RE: Summary of Series 3 Monitor Well Program

# Technical Memorandum

## *Results of Preliminary Groundwater Testing and Geophysical Surveys*

<b>To:</b>	Matt Banta, Confluence Water Resources	<b>Date:</b>	August 16, 2021
<b>Cc:</b>	Cindi Byrns, Fort Cady California Corp	<b>Project:</b>	Update Fort Cady GW Model
<b>FROM:</b>	Garrett Frey, Hydrogeologist Daniel Pasteris, PhD Geochemist and Hydrologist Dwight Smith, PE PG, Principal Hydrogeologist	<b>Project No:</b>	APB-006
<b>SUBJECT:</b>	Lithological Review of 2021 MW OW and AOR Drilling, Fort Cady Borate Mining Project

Series 3 Holes  
Cross Section

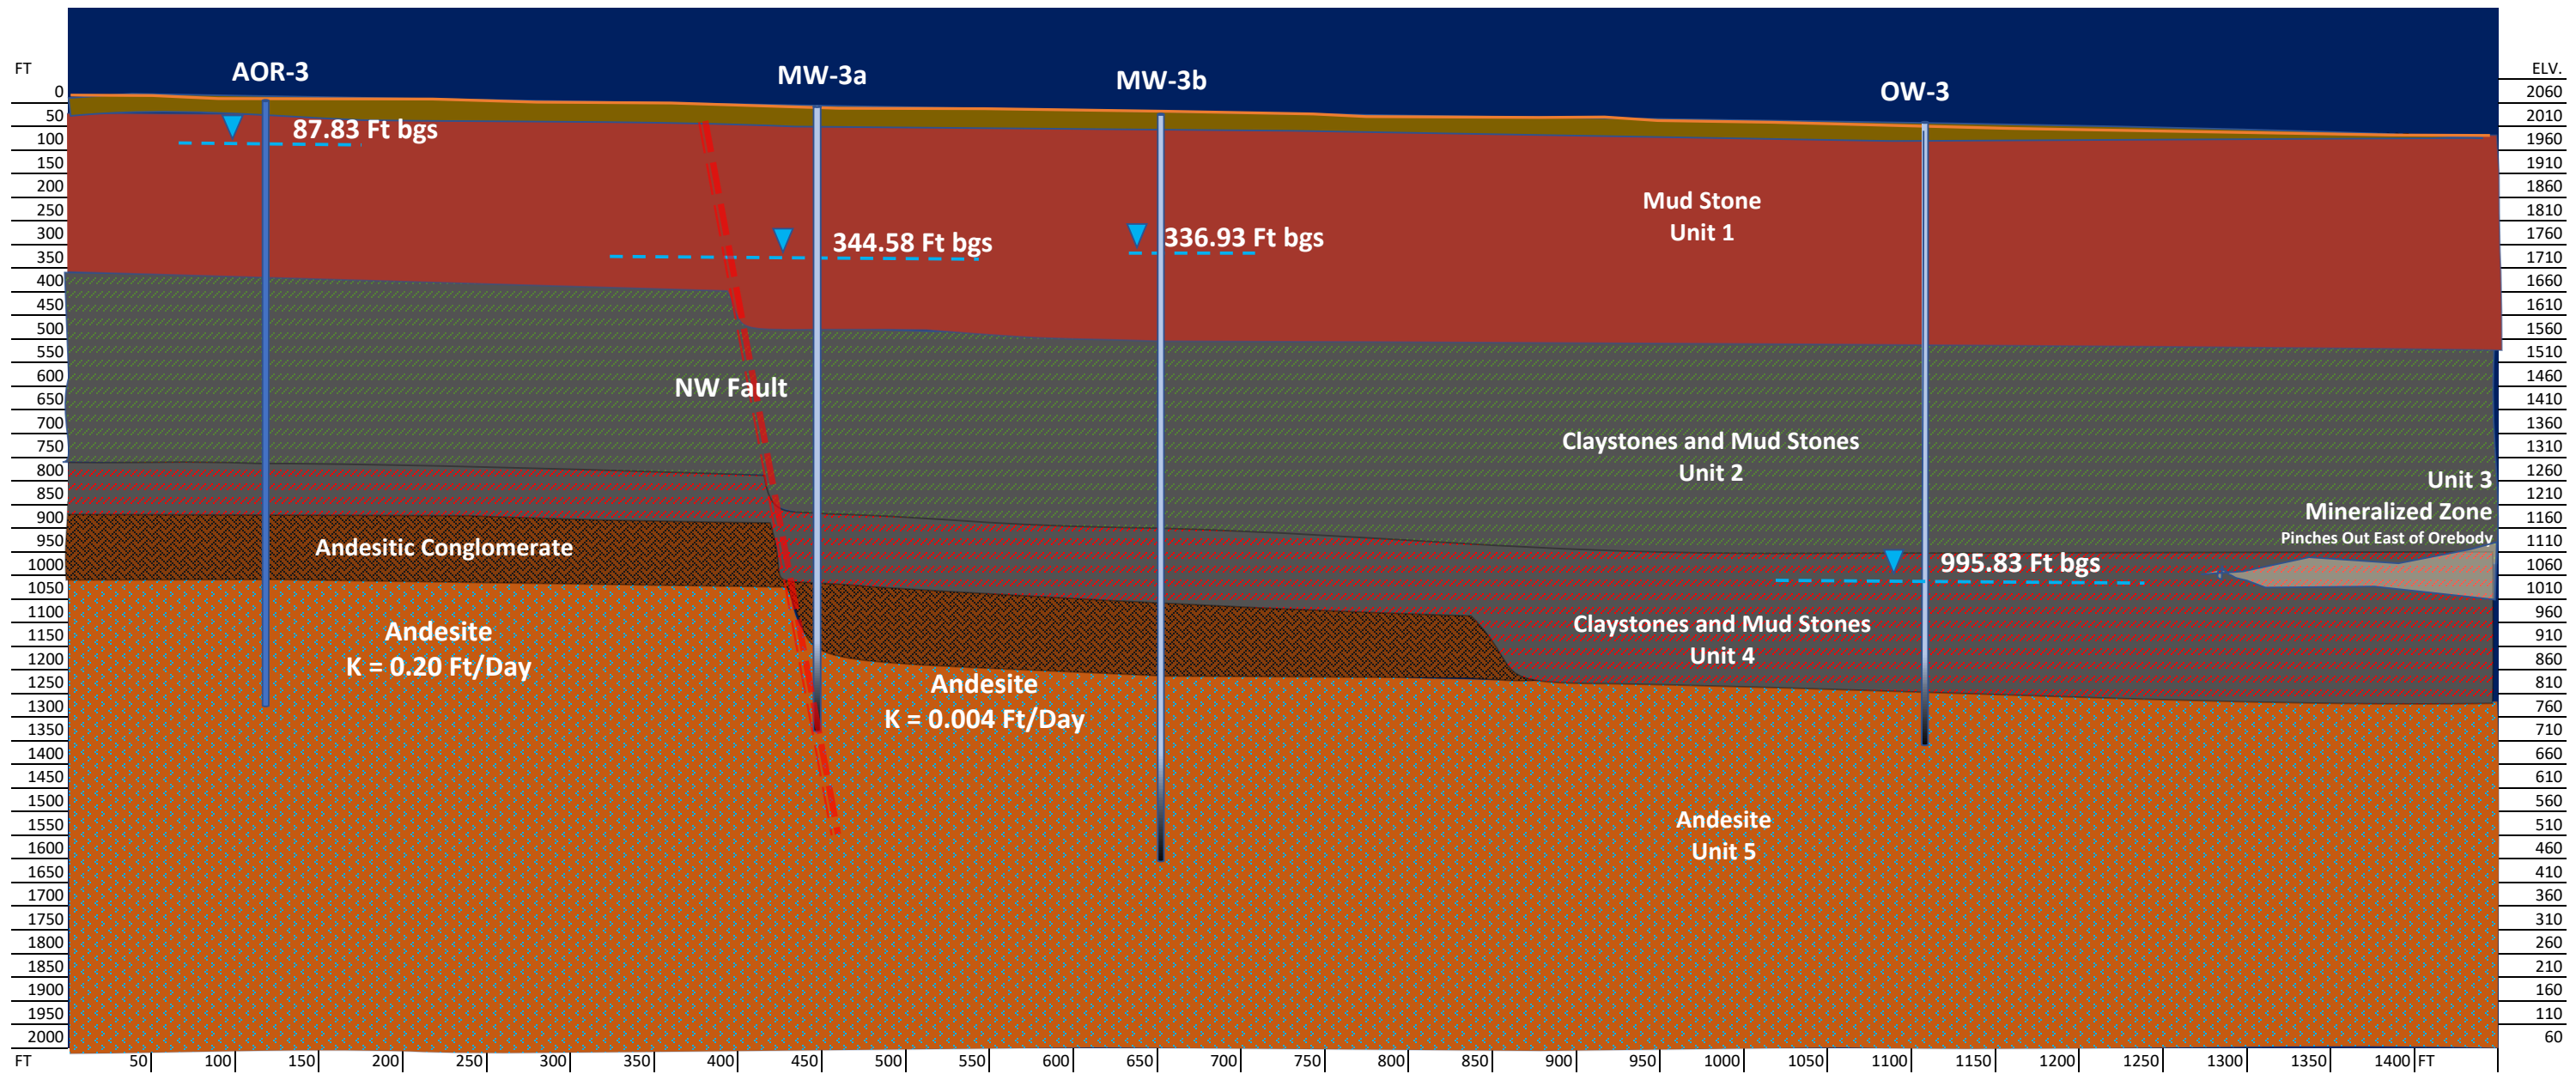
- Several logs have the contact of the base of Unit 1/top of unit 2 logged at the color change that exists at the redox boundary. This causes the contact to appear to have no dipping angle.

- The contact between Unit 1 and 2 is characterized by the transition from a coarser sandy/silty mudstone to finer grained mudstones. This is observed in the borehole geophysics and is captured in several of the chip logs. A reinterpretation of this contact using these criteria, shows the Unit 1 and 2 contact dipping gently  $\sim 10^\circ$  to the southwest.

- In holes MW-3b and OW-3, the top of an interval of anhydrite/gypsum rich mudstones occurs at  $\sim 700$  and  $740$  feet bgl respectively, and in MW-3a there is a very clean mudstone that occurs at a comparable depth. This anhydrite/gypsum bearing bed also has a shallow  $\sim 10^\circ$  southwest dip and projects on the southeast looking cross section between these holes to the southwest to where the Unit 3 is interpreted to have pinched out. It is likely that this is the continuation of Unit 3 which, while not hosting borate mineralization, still contains other evaporites in lacustrine sediments and could be the result of thinning or a facies change towards the deeper portion of the paleobasin.

- The top of the conglomerate at the base of the lacustrine sediments is very pronounced in both the chip logging and the borehole geophysics. It is denoted by a sharp increase in coarseness of the sediments and a mixed lithology of basalt, tuff, sandstone, and mudstone. This volcanic dominant basal conglomerate is commonly found at the base of the Tertiary sediments in the Mohave. It is likely Eocene in age and is significantly older than the lacustrine sediments. It is generally strongly cemented. In many logs this volcanic conglomerate is still logged as andesite, notably in hole OW-3.

- An over representation of the basal conglomerate is logged in many of the recent chip logs due to substantial caving/collapsing of this unit during drilling. In some cases, notably MW-3b, the base of the conglomerate was likely penetrated, but due to the overwhelming volume of sample ejected

7. The ~1 foot of fault gouge intersected in MW-3a can be interpreted as a zone of shearing, rather than a large northwest striking fault that offsets stratigraphy. Chip logging above and below doesn't report mixed lithology types or other damage zone indicators that should accompany a fault of that magnitude. The offsets in units could potentially be explained with southwest dipping beds and a volcanic bedrock that shallows to the northeast, or with dipping beds with much less apparent vertical offset along this structure.

2. The existing geologic modelling or cross sections should be updated to account for the ~10° dip of the units.
3. Targeting of future wells could be assisted by geologic modeling of the gently inclined beds. The down or up dip depth of the desired strata for well screen installation could be projected from the model and be the basis of the well design and drilling plan. This could prevent future over drilling, and keep the monitoring/observation wells located within the lacustrine sediments.

4. For modelling purposes, grouping the andesitic conglomerate and the andesite bedrock into an undifferentiated volcanic unit is preferable since the conglomerate has an irregular surface and is more closely associated with the andesitic bedrock than the lacustrine sediments.
